The Timberyards by RTL Co. SSDA RTS Comments

Prepared for RTL.co
May 2025

Rev A Issued May 2025

Masterplan Landscape

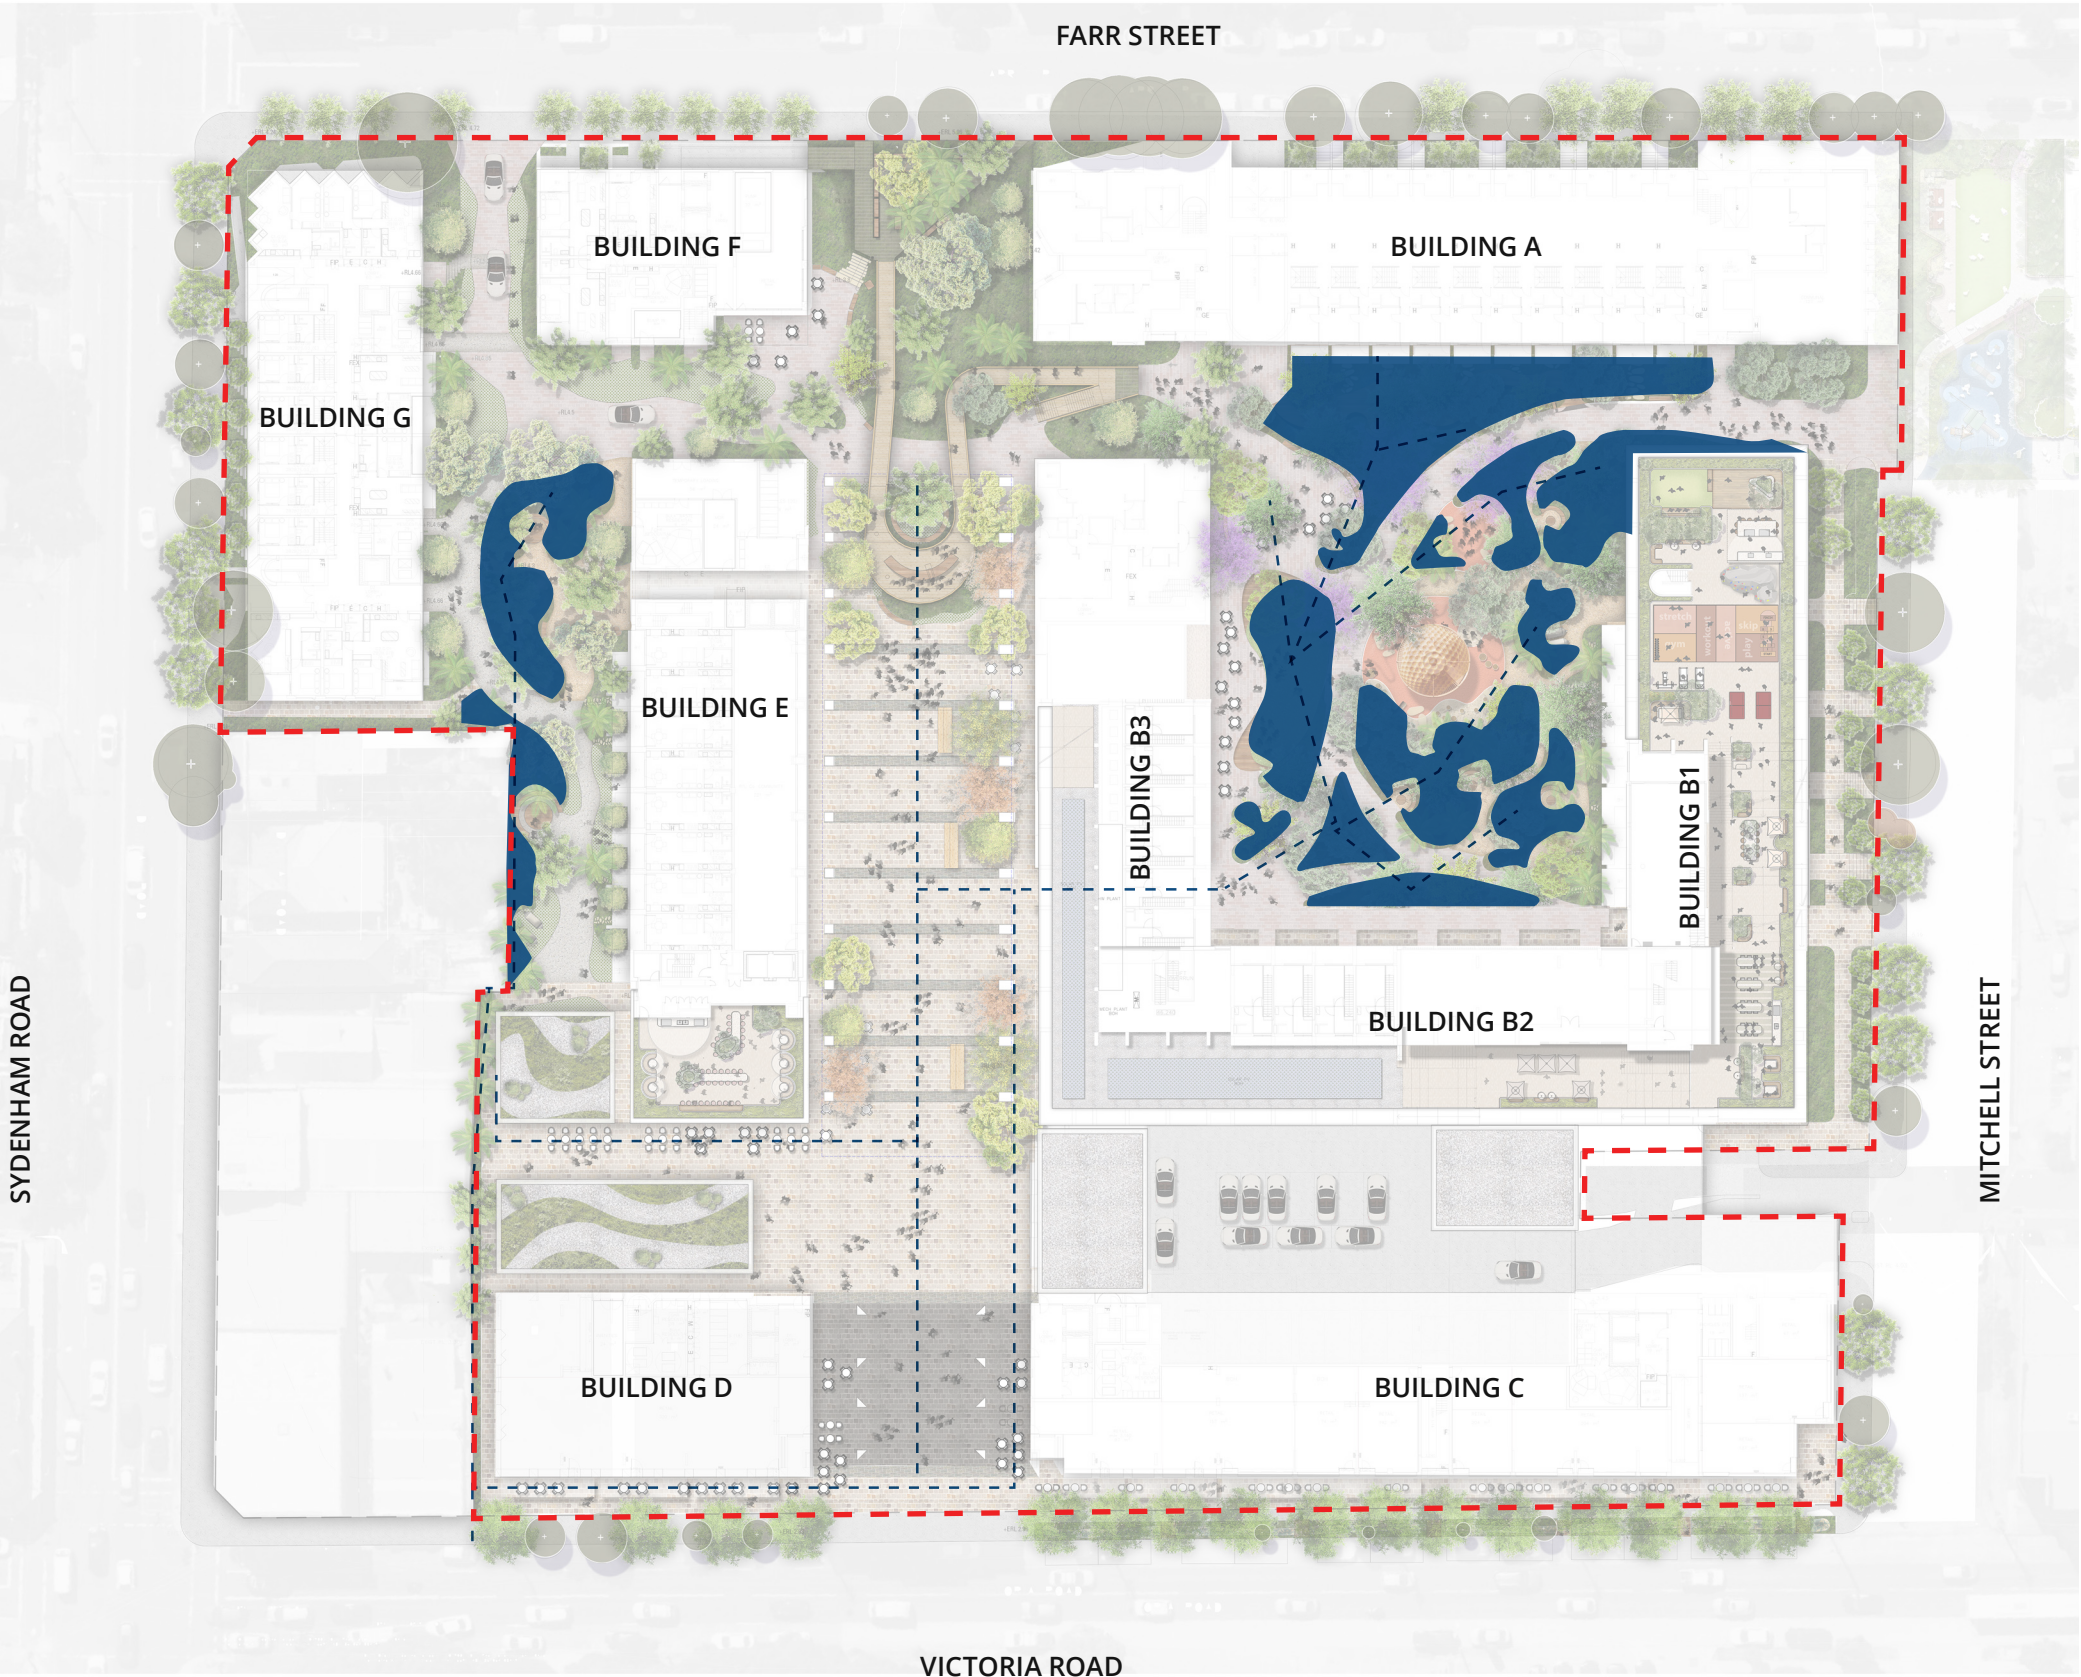
Address soft landscape water treatment measures as per the Marrickville Council WSUD Reference Guideline.

The Public Domain and Landscape Design will implement best practice Water Sensitive Urban Design Principals. The diagram adjacent looks to provide a series of solutions that look to manage the storm-water to both passively irrigate the landscape and treat the water in a high flow event.

We have identified water sensitive urban design site-wide opportunities and constraints through design including the overview of safety, capital management, water quality, urban content, impervious catchment and geology and soils.

The use of on-site detention, bioretention, urban basins, porous and permeable pavements all contribute to a cohesive water sensitive urban design outcomes. Water re-use and integration within is made visible, demonstrating sustainability and linking directly to the historic narrative of the site.

Masterplan
Landscape

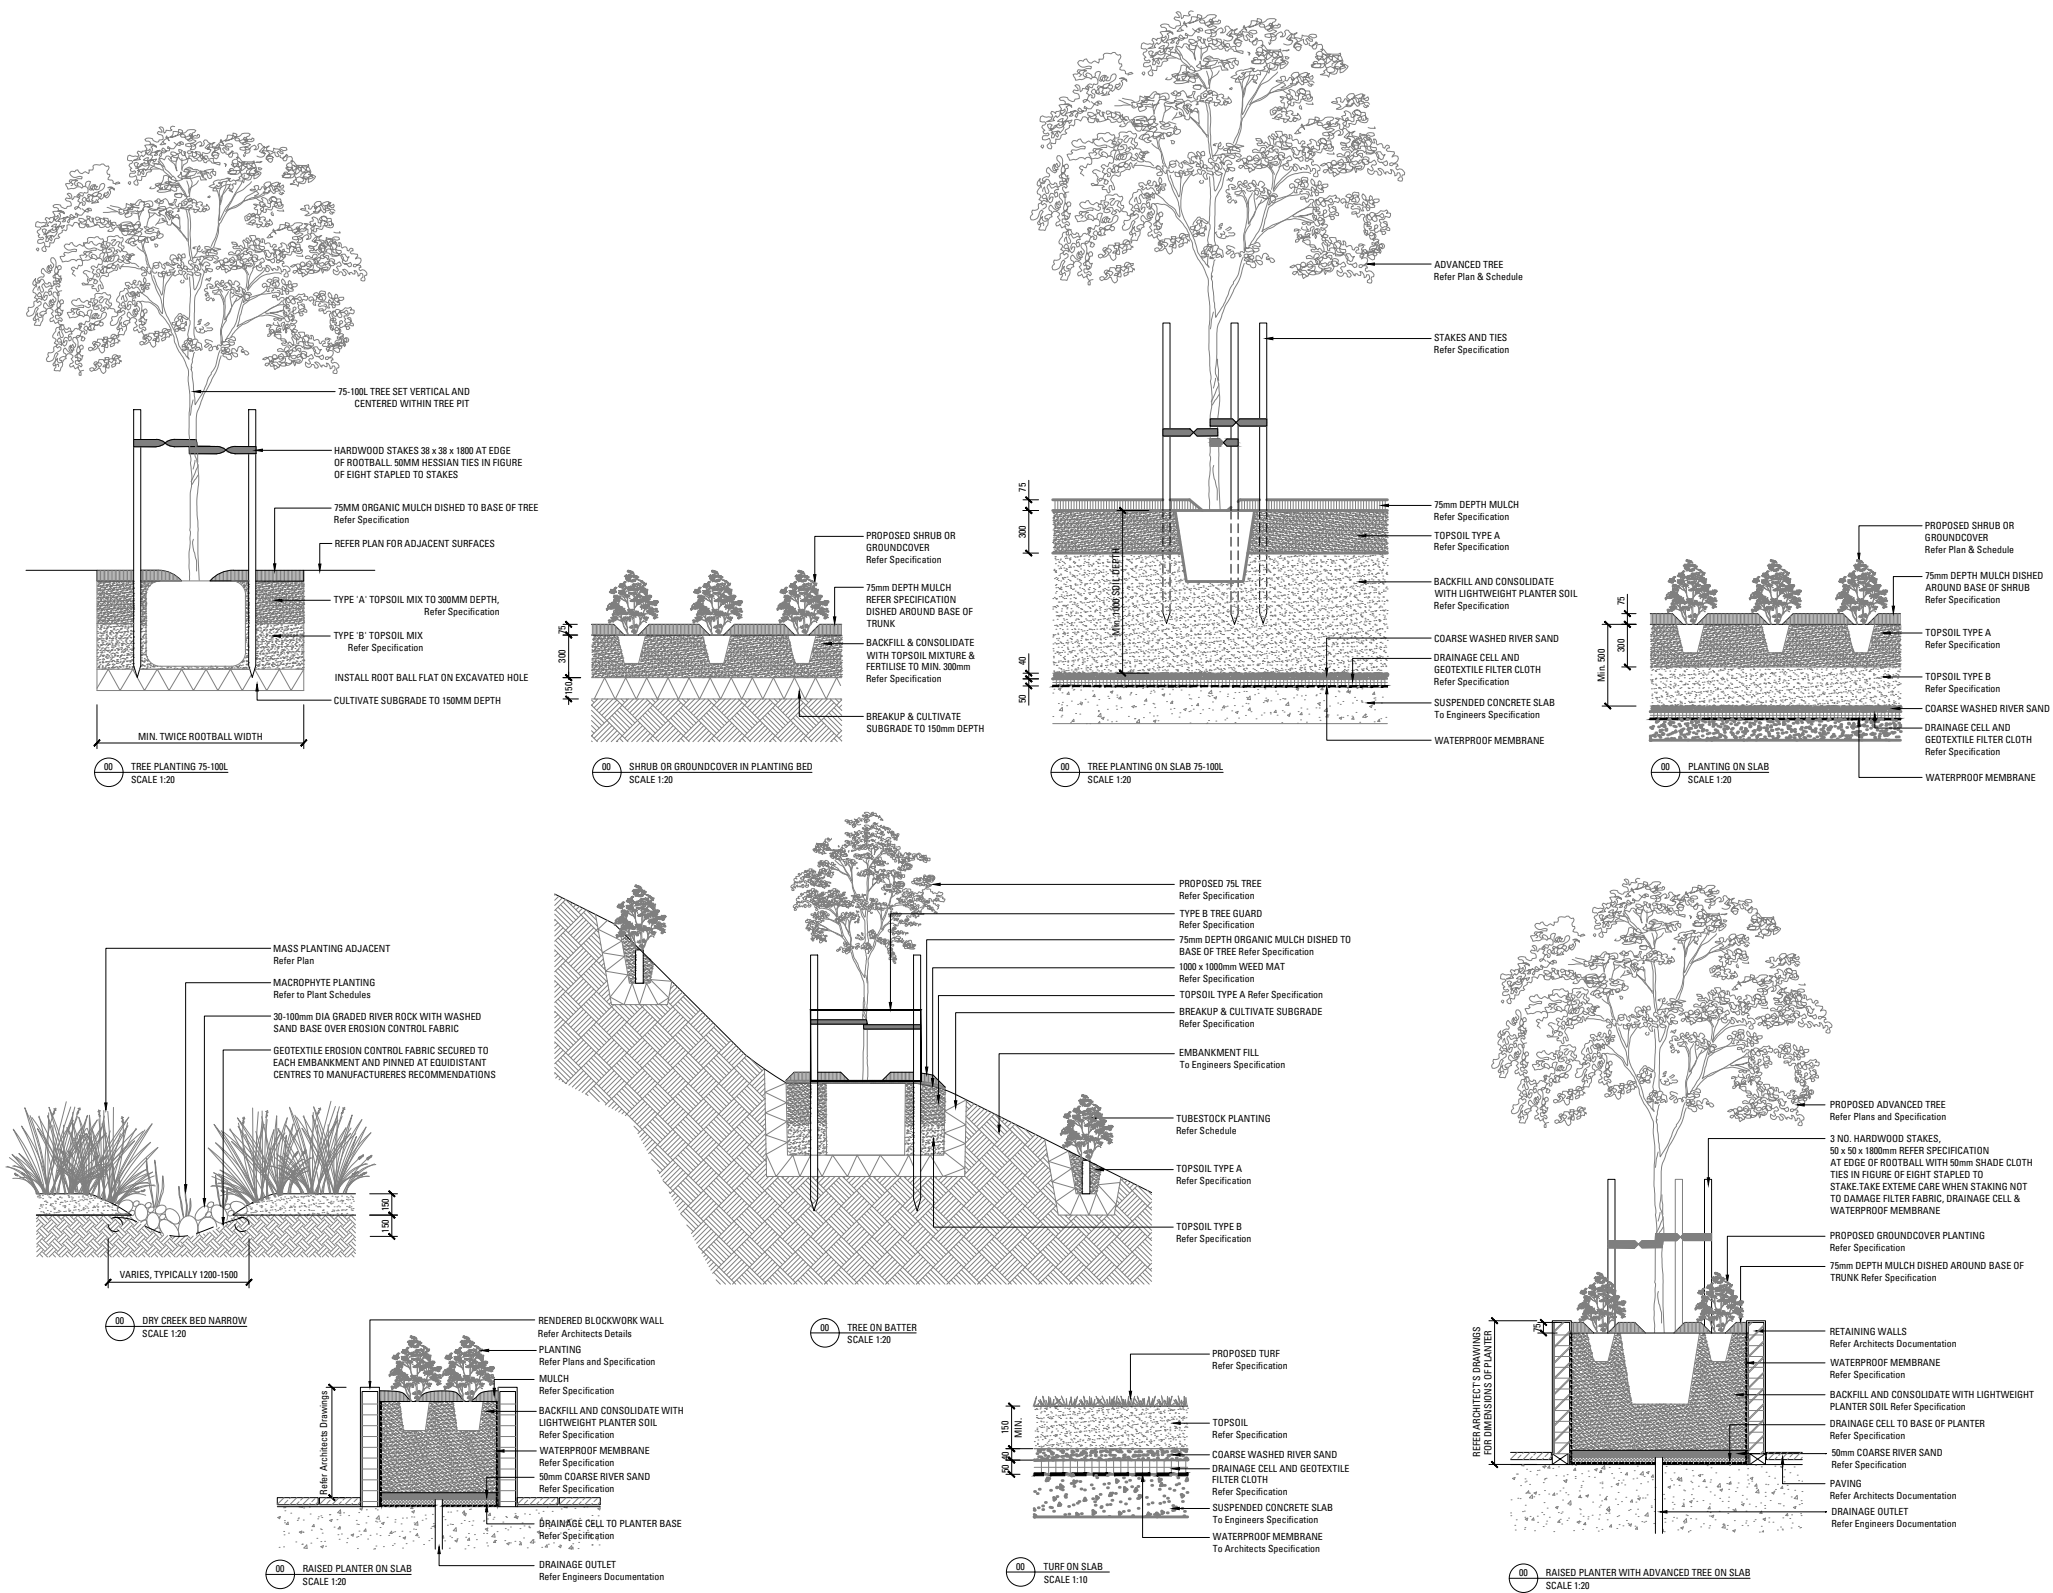
Review of proposed planting stock to ensure compliance with AS2303.

Provide Council with certification that all street tree plantings comply with this standard.

AS 2303 specifies the criteria for the assessment of above-ground and below-ground characteristics of tree stock that are to be supplied for landscape use. We will ensure that AS 2302 is upheld as a requirement.

Masterplan
Landscape

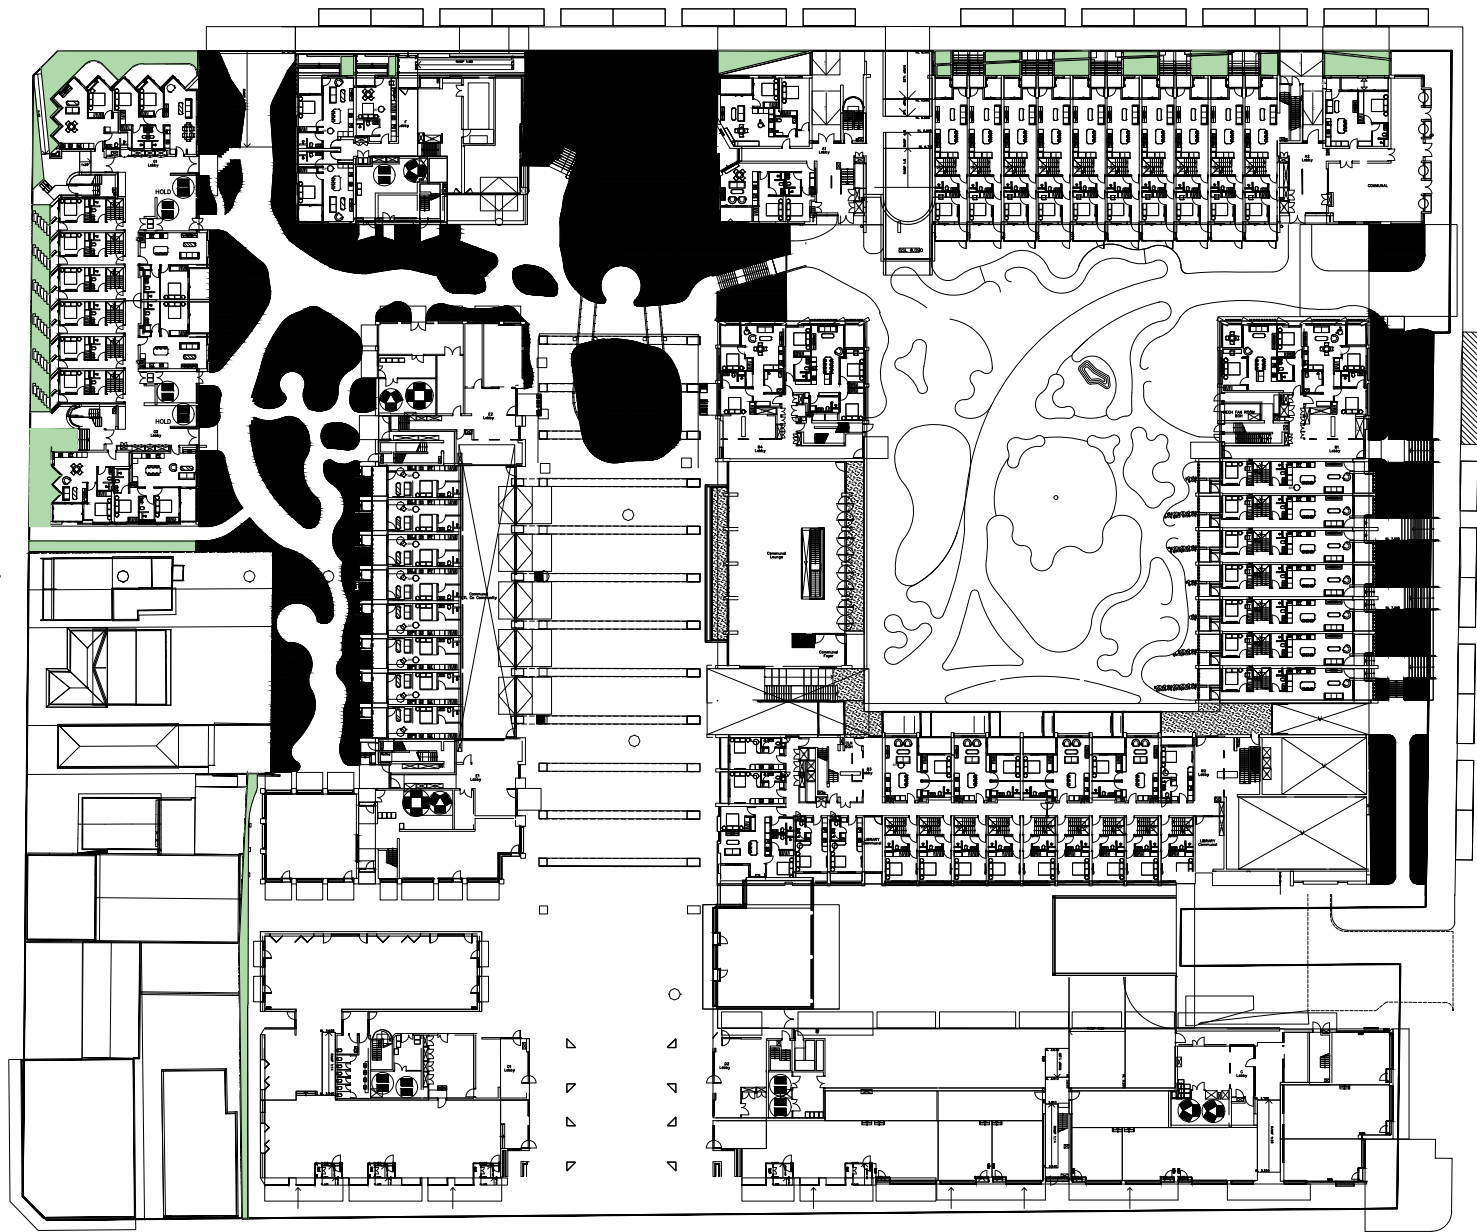
Review provisions of deep soil and communal open space to demonstrate compliance or provide justification.

Design guidance from ADG Objective 3E-1 stipulates that a total 7% minimum deep soil planting area must be achieved. The design currently satisfies this with a total area covering 9.62% of the site (1,748m²).
